Response to Neighbor Concerns

Prepared by Deepak Gupta and team, on June 26-28, 2026

Submitted to Town of Los Gatos on June 29, 2026

Figure B0. The proposed second story (green star) does not immediately abut the subject neighbor's property line (red star and red line). The correct direction between the two structures is Northeast (not East).

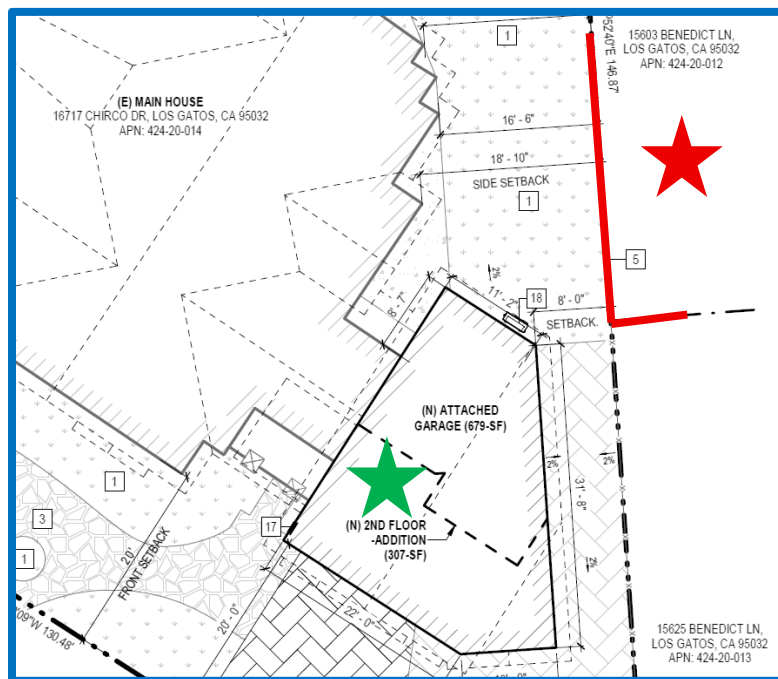
The neighbor's conceptual exhibit was also reviewed and appears to depict a very long, low-angle shadow. However, the exhibit itself is labeled as conceptual and is not a scaled or surveyed shadow study so it is unclear exactly how to use this. From a geometric standpoint, an approximately **85-foot shadow** from a **26.5-foot-tall structure** would require a sun elevation angle of only **17.3 degrees above the horizon**. This represents a very low-angle sun condition, typically associated with dusk rather than standard daytime conditions. It is not typical for shadowing during dusk to have material adverse impact, as **it is brief and expected** before sunset. The conceptual drawing is also inaccurate as it positions the subject neighbor directly east of the proposed second story which is not accurate. An accurate figure depicting the proposed configuration is included here with no immediate abutment along his property line (15603 Benedict) line.

Figure C1. Above. Submitted design with rear gable roof.

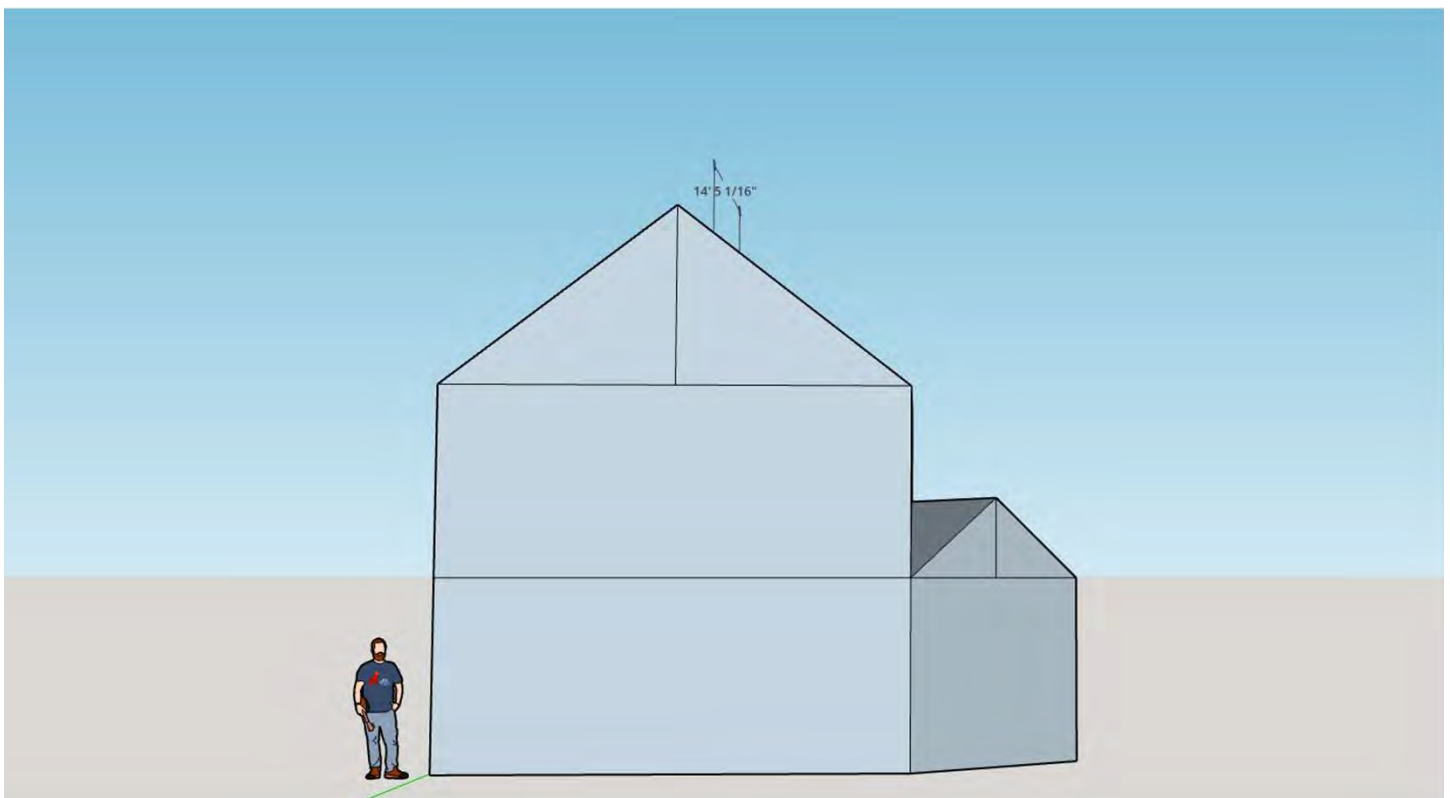
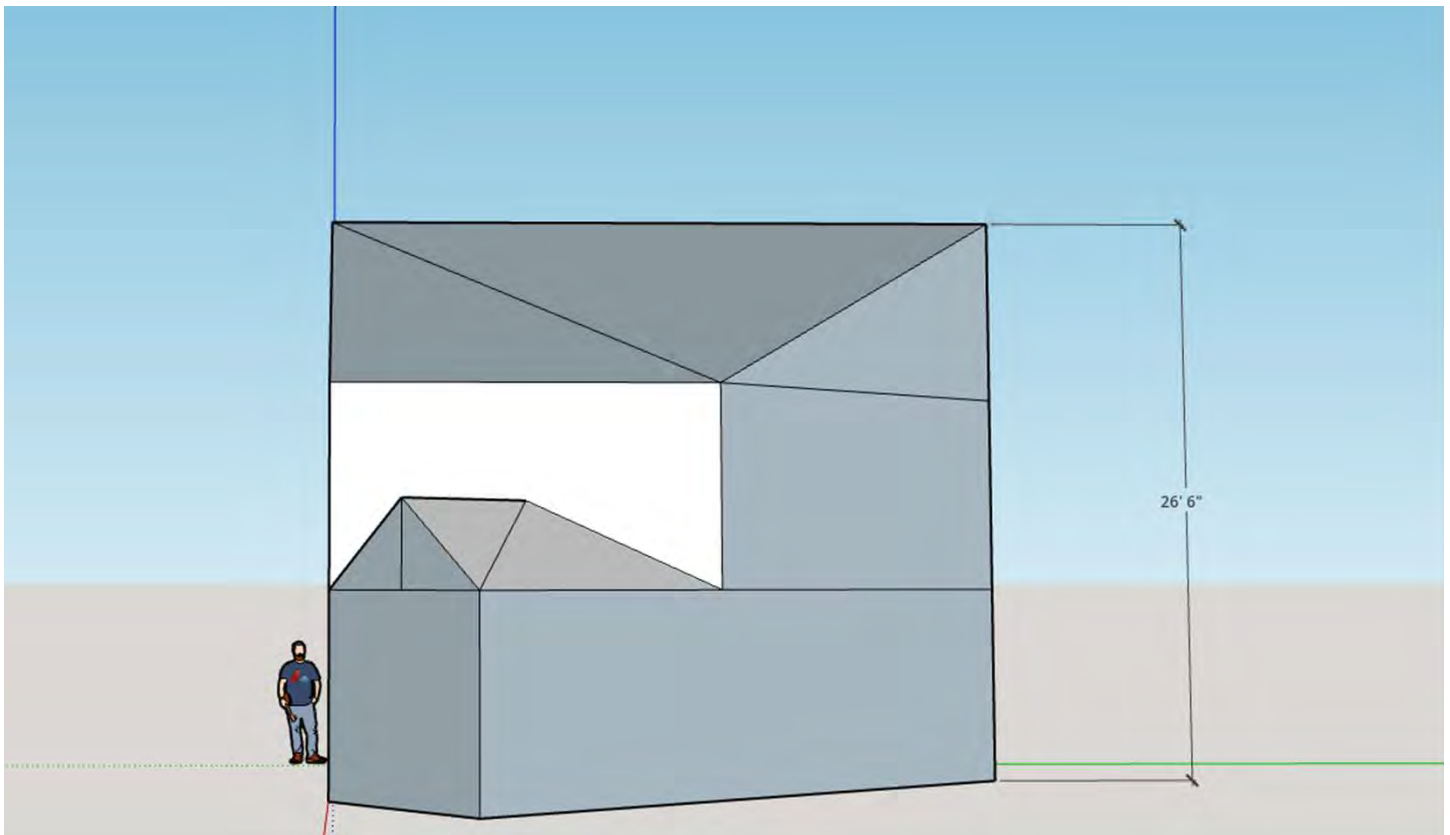
In the spirit of compromise and good faith collaboration, one suggestion we have is to possibly consider changing the rear roofline from gable to hip. This would reduce the rear height (from 26'6" to 18') that is diagonal and visible from the subject neighbor's backyard. This is a proposed rear height reduction of ~33%. This would unfortunately disrupt the Craftsman architectural consistency at the rear façade that was required by the Town of Los Gatos during the review process, but would have a potential benefit of reduced height and mass at the rear closest to the subject neighbor. This would also push the maximum height of the roof ridge *away* from subject neighbor by 14' 5" per his request. This would still be subject to design and engineering, and planning approval. This alternate design and engineering has been requested to assess feasibility, but due to the short notice, has not yet been completed. See preliminary 3D drawings (*to scale*) which are **ATTACHED (C1-C8)**.

Figure C2. Below. Rear roofline modified to hip instead of gable.

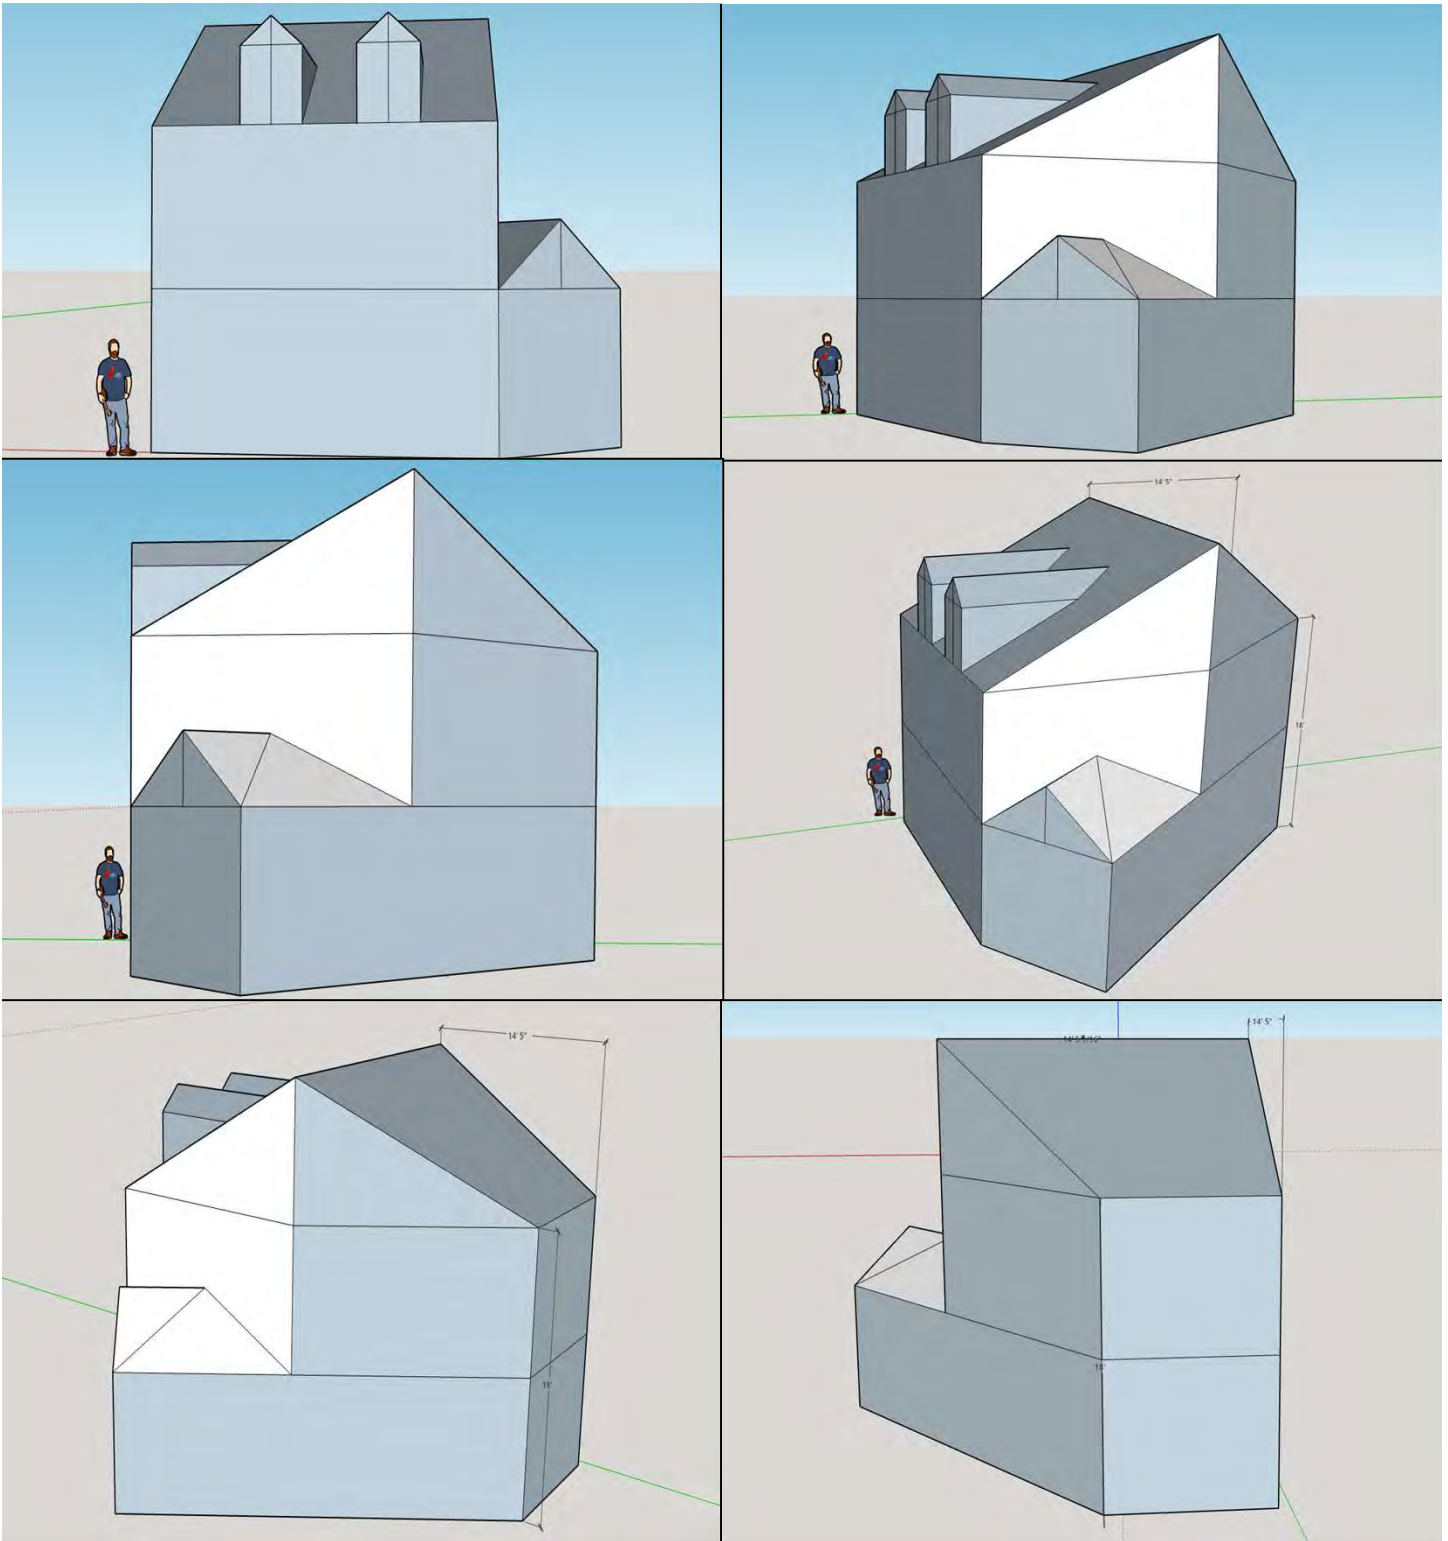
A second last-minute alternative design is also preliminarily included in **ATTACHED FIGURES C9-C14**. This design has not yet been engineered or assessed for viability.

Figure C9-C14. A second possible alternative roof design is included to blend gable and hip styles to reduce rear height and still maintain some architectural consistency. Due to the short notice of this response, this conceptual design has not yet been fully designed or engineered to assess viability. Dormer windows would blend well with existing structure.

**Figure
B2**

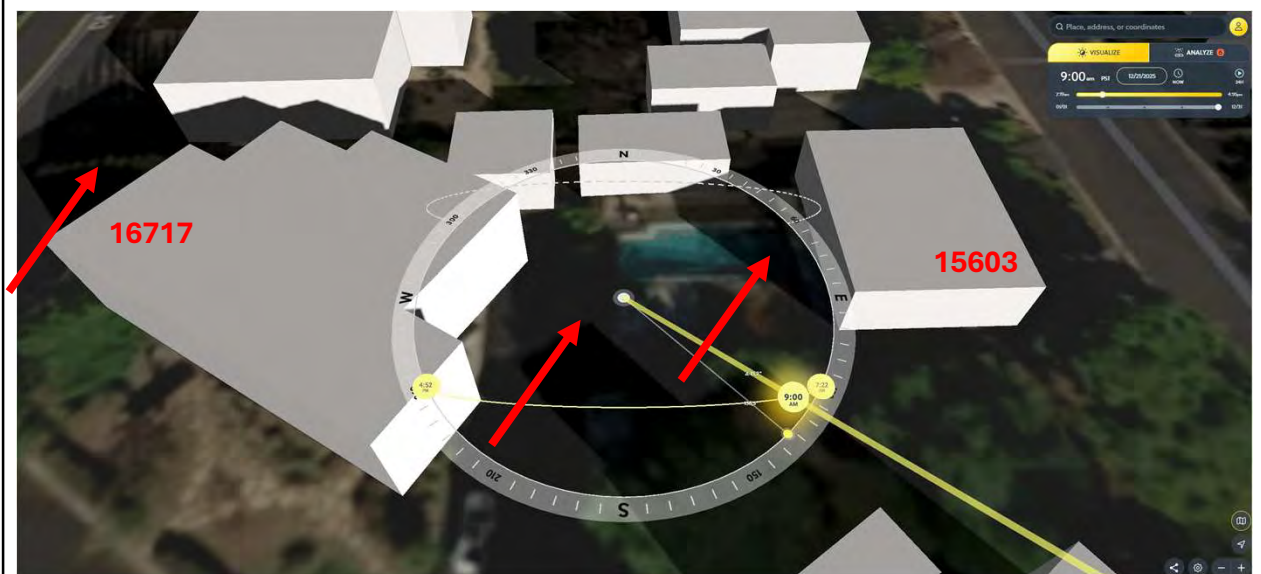
The neighbor's pool is overshadowed by the neighbor's own home (15603).

Planned open space/landscaping on our property (16717) is overshadowed by the neighbor's rear lot trees.

There is no shadowing of the neighbor's (15603) lot by our property (16717).

**Figure
B3**

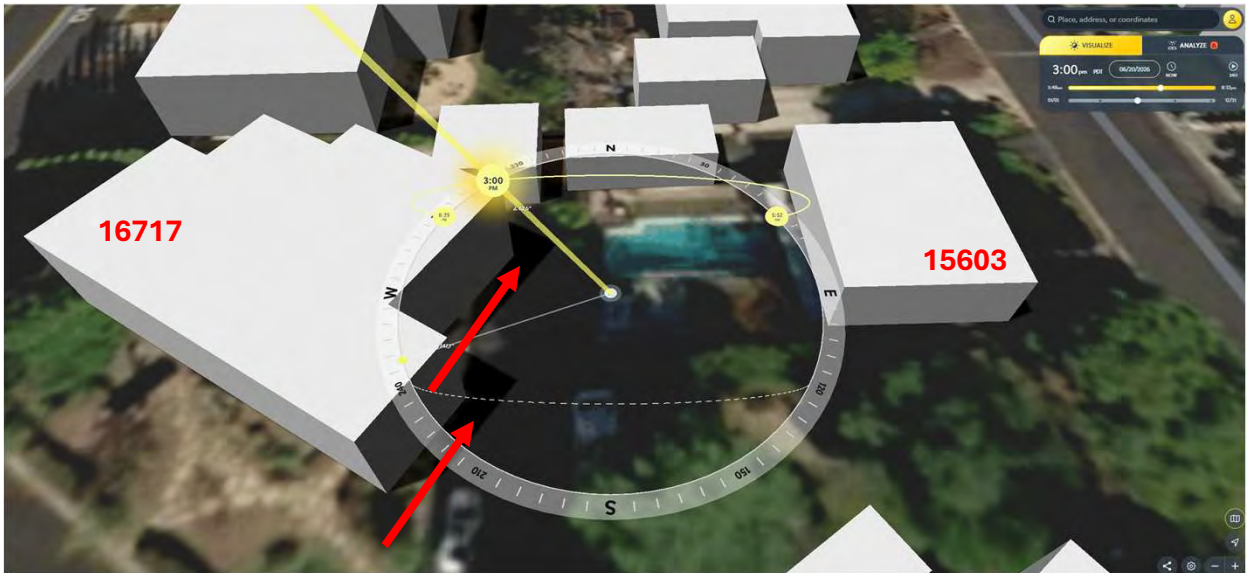
There are no shadow concerns.

Our (16717) property has a short shadow that does not impact the neighbor's (15603) property.

**Figure
B4**

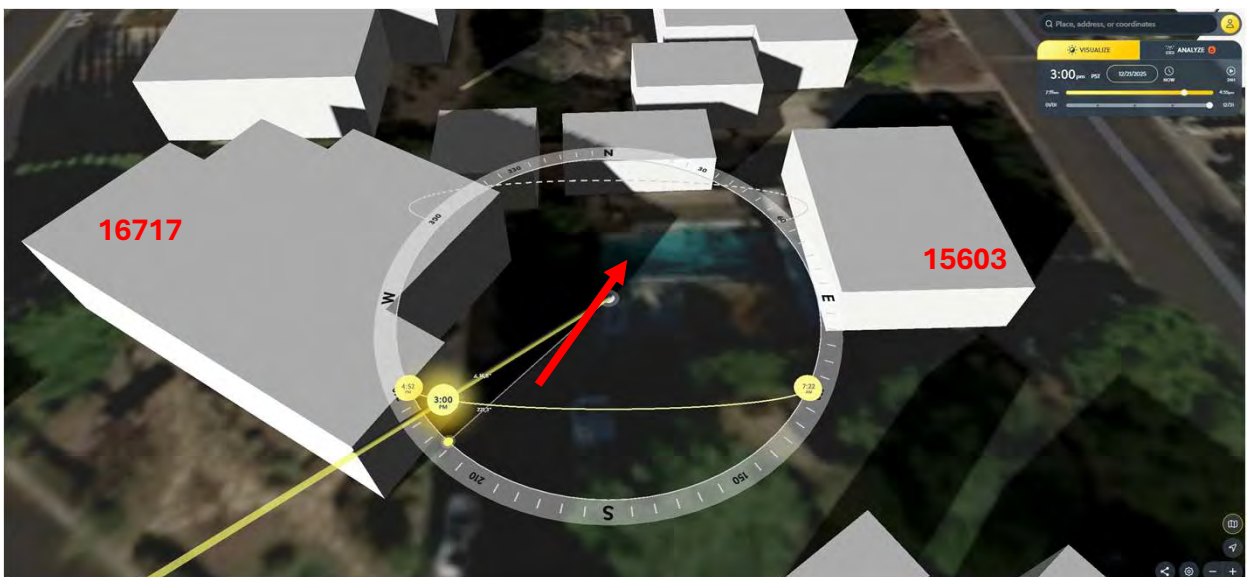
The **existing** shadow cast by our main home results in partial shadowing of the neighbor's pool and trees during the late afternoon in winter only, when the trees have no leaves, and the pool is not actively warmed nor used. This is already **existing**.

Figure
B5

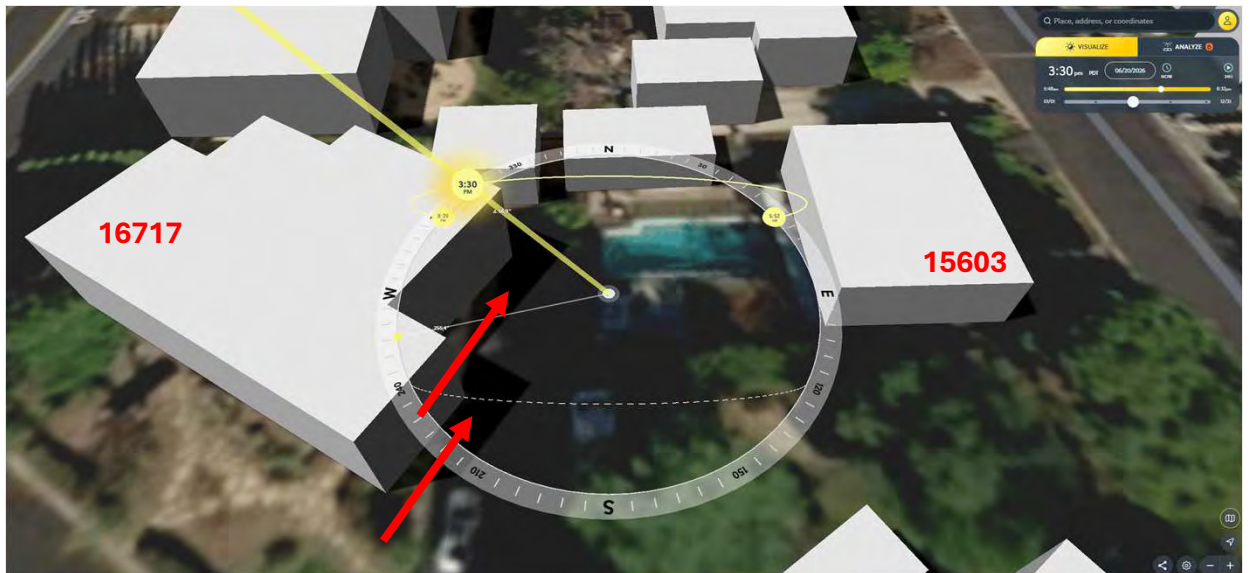
There are no shadow concerns.

Our (16717) property has a short shadow that does not impact the neighbor's (15603) property.

**Figure
B7**

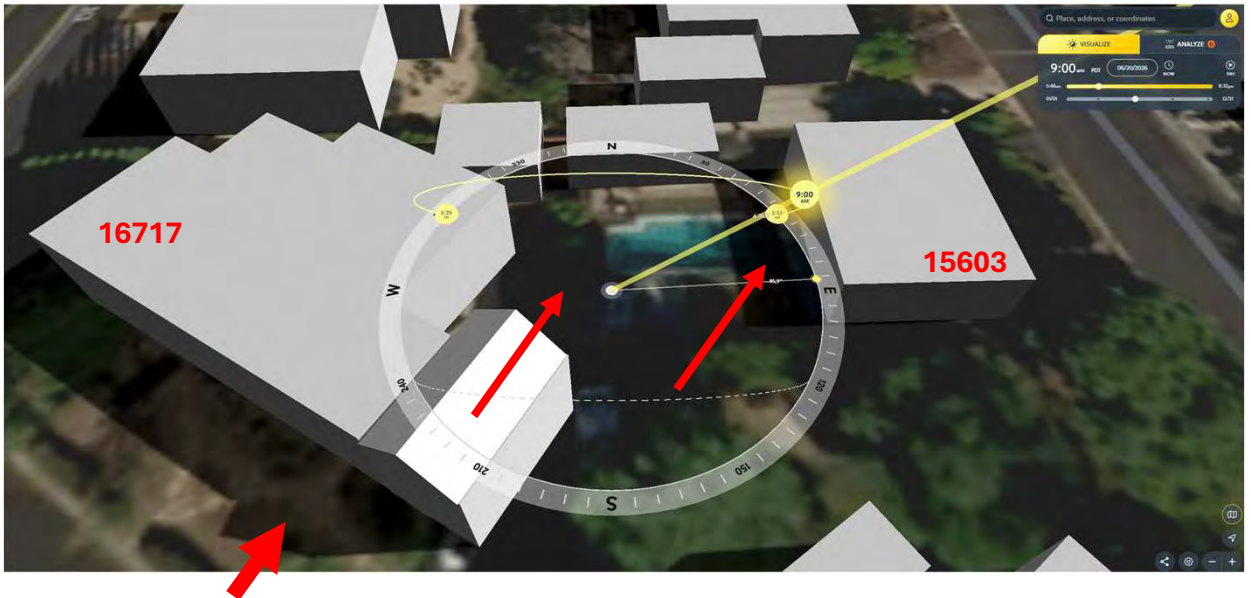
The proposed second story casts a shadow **to the west** and does not impact the neighbor's property (pool, trees, landscaping, residence, etc.) whatsoever.

The neighbor's pool is overshadowed by the neighbor's own home (15603).

Planned open space/landscaping on our property (16717) is overshadowed by the neighbor's rear lot trees.

**Figure
B8**

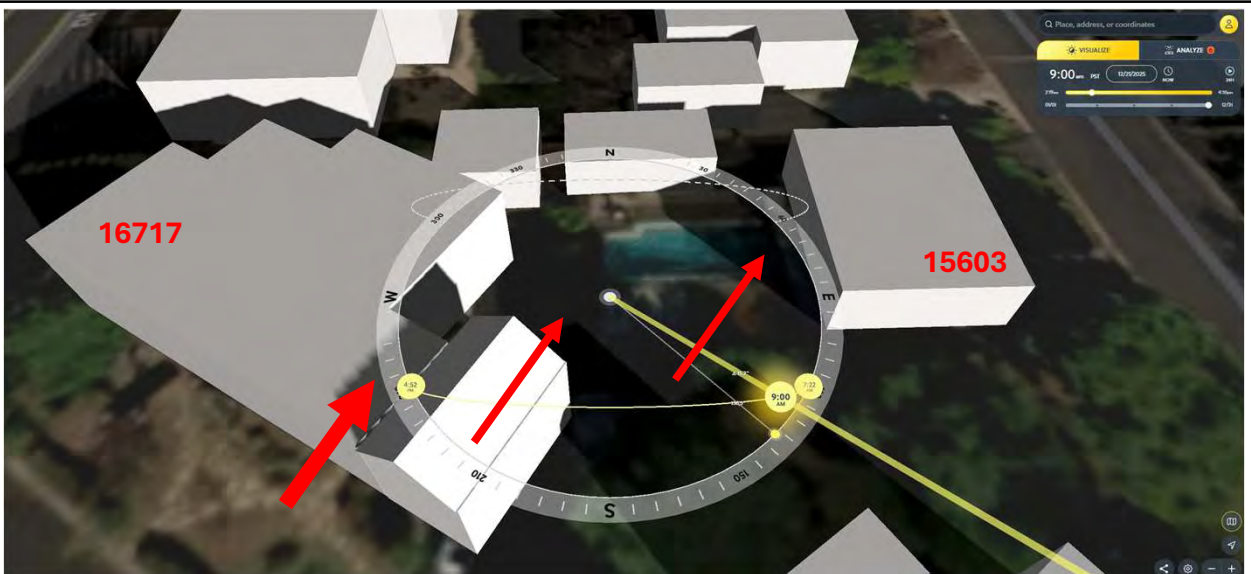
The proposed second story has shadow **to the northwest** and does not impact the neighbor's property (pool, trees, landscaping, residence, etc.) whatsoever.

The neighbor's pool is overshadowed by the neighbor's own home (15603).

Planned open space/landscaping on our property (16717) is overshadowed by the neighbor's rear lot trees.

Figure
B9

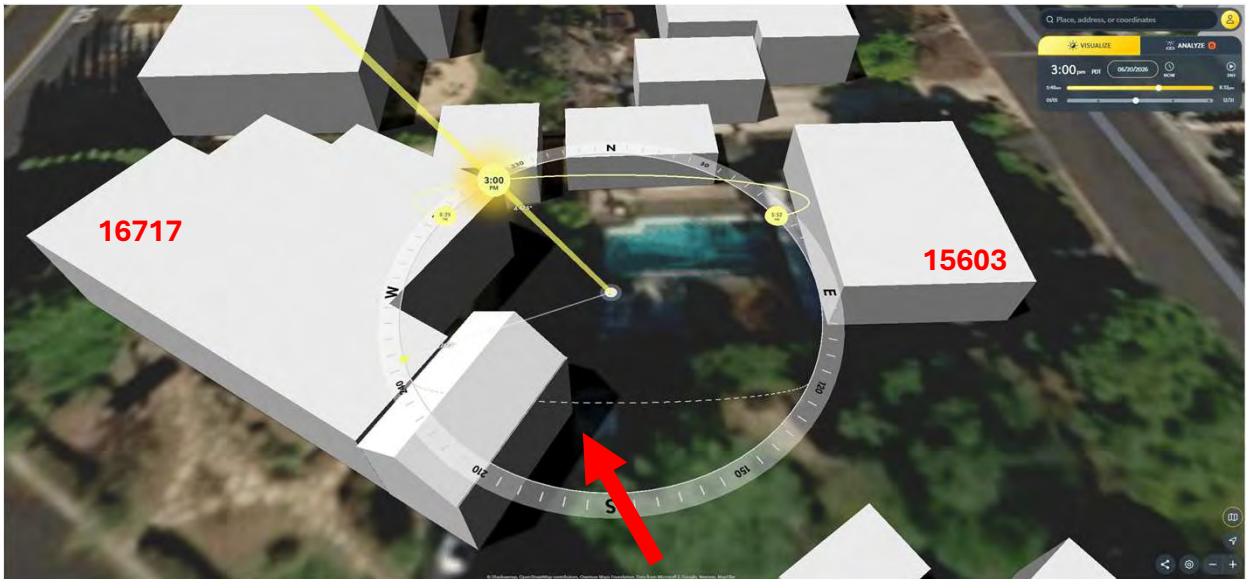
There are no shadow concerns.

Our (16717) property **and second story** have a short shadow that does not impact the neighbor's (15603) property.
